UNITED STATES PATENT AND TRADEMARK OFFICE

APPLICATION NO.	FILING DATE	FIRST NAMED INVENTOR	ATTORNEY DOCKET NO.	CONFIRMATION NO.
10/719,352	11/21/2003	John R. Wall	3257-031853	3304

DETAILED ACTION

The following title is suggested: Connection system for plastic web fencing.

Figure 1

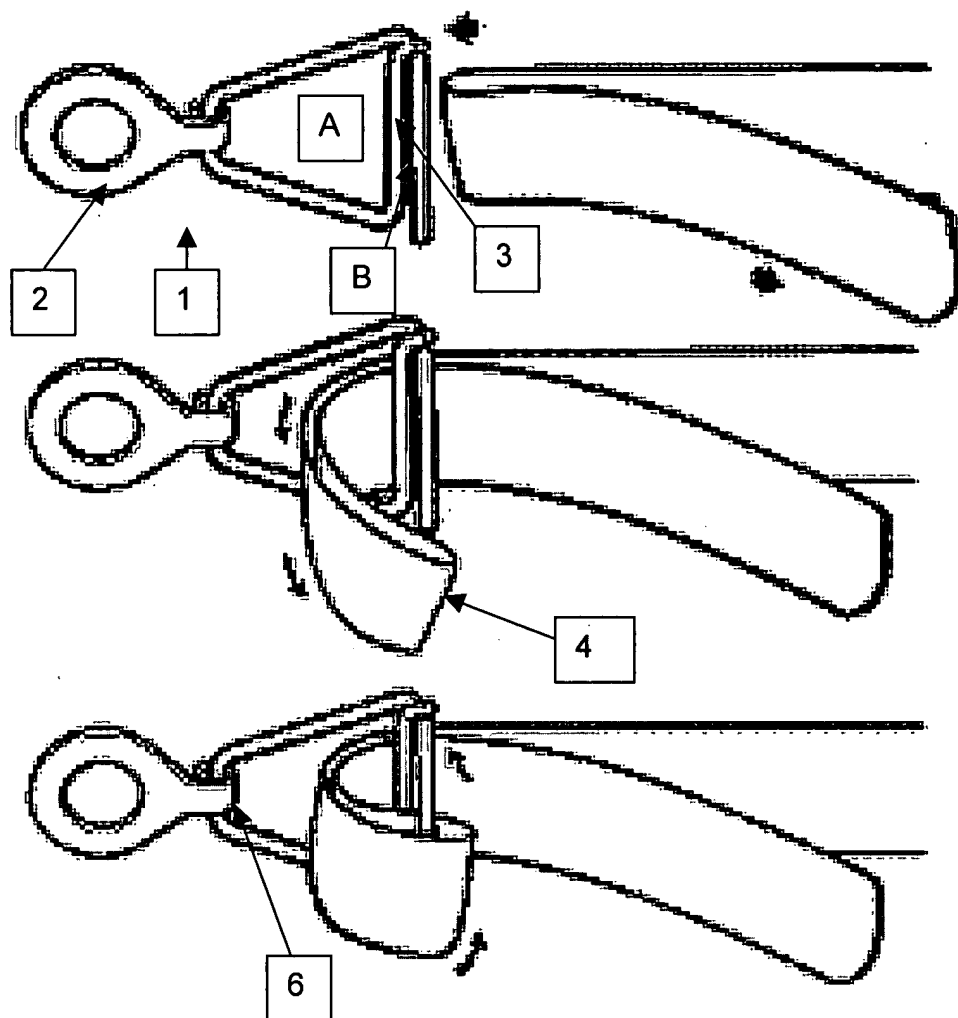
As to claim 1, Safe-Fence discloses a fence comprising a rail consisting of at least two metal wires ensheathed in a plastic web (the webbing used for the fence is disclosed as having stainless steel wires interwoven), a slotted connector (1) having a face plate (encompasses the entirety of 1) with two slots (A and B) and a middle portion (3) separating the two slots, the connector having a front side (facing away from reader)

and a rear side (facing toward reader) and also having a post attachment end (2), a free end of the rail (4) being disposed in the slotted connector so that the rail runs from the front side of the connector through a first slot (A) nearest the post attachment end, round the middle portion (3), and then back through the second slot (B), and a post (5) to which the end connector is attached using a fastener (5).

As to claim 3, Safe-Fence discloses a fence wherein the end connector is attached to the post using a fastener (see figure 1) which permits the connector to pivot about the fastener.

As to claim 6, Safe-Fence discloses a fence wherein the faceplate (encompasses the entirety of 1 includes a bend between the first slot and the post attachment end (2) (this is shown in figure 1 in the photo of the R-50 corner tensioner).

Figure 2

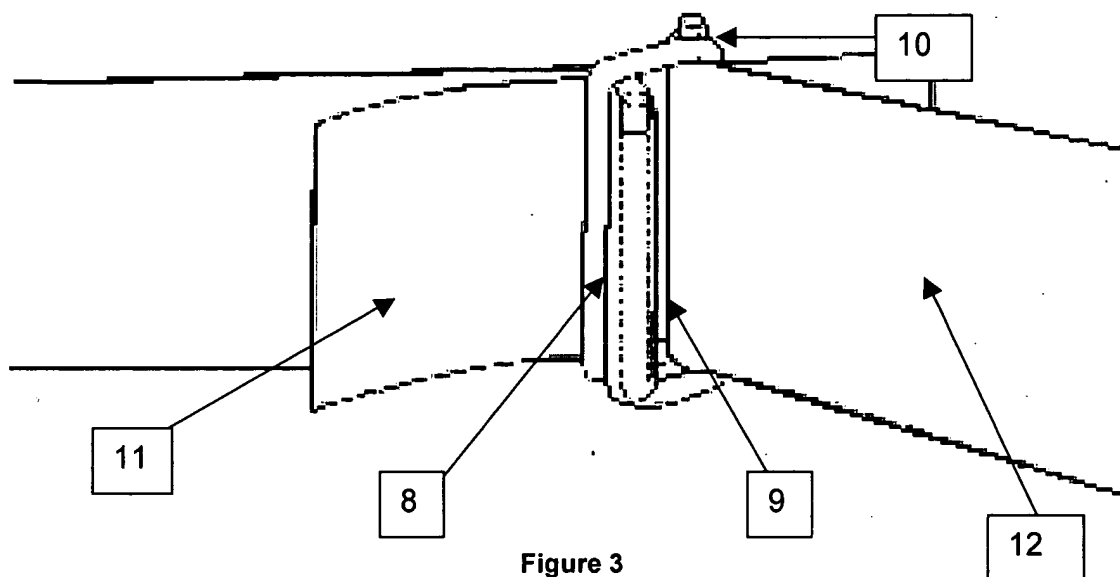
As to claim 10, Safe-Fence discloses a fence further including a slotted joining connector (7) having a face plate with a first slot (8), a second slot (9), and a third slot (10), the joining connector having a front side (into the paper) and a rear side (out of the paper).

As to claim 11, Safe-Fence discloses a fence further comprising a second rail (shown in figure 3) consisting of at least two metal wires ensheathed in a plastic web, with ends of the first (11) and second (12) rails being in abutting relationship to each other (see figure 3).

As to claim 12, Safe-Fence discloses a fence wherein the first slot (8) and the second slot (9) are adapted to receive the abutting end of the first rail (11) and the second slot (9) and the third slot (10) are adapted to receive the abutting end of the second rail (12).
